PLANNING APPROVAL STAFF REPORT Date: November 1, 2007

APPLICANT NAME Stewart Memorial CME Church

CONTEMPLATED USE Planning Approval to allow a sanctuary entrance expansion to an existing church in an R-2, Two-Family Residential District. Planned Unit Development Approval to allow two buildings on a single building site.

SITE PLAN

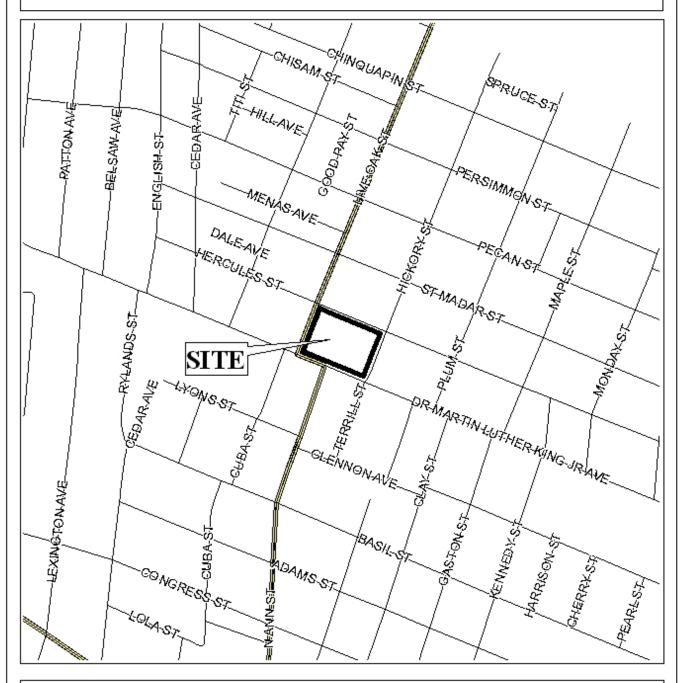
While the addition of a vestibule may seem insignificant, the addition in question is two-story, and provides additional seating space for approximately 73 people (based on load calculations provided in the application packet). This potential seating would increase the parking requirements by 19 spaces. There is a minor concern relating to parking overall. While the plan submitted depicts

parking areas, it does not illustrate or denote the number of parking spaces provided. Based upon the seating capacity (which is the measure upon which parking requirements for a church are based), the minimum number of parking spaces required would be 100 (1 space/4 seats).

- 1) submission of a revised site plan illustrating the provision of minimum required parking, or the submission and approval of a variance prior to the issuance of a Certificate of Occupancy;
- 2) provision of two frontage trees, to be planted along the Dr. Martin Luther King, Jr Avenue frontage, in or near the project area; and
- 3) full compliance with all municipal codes and ordinances
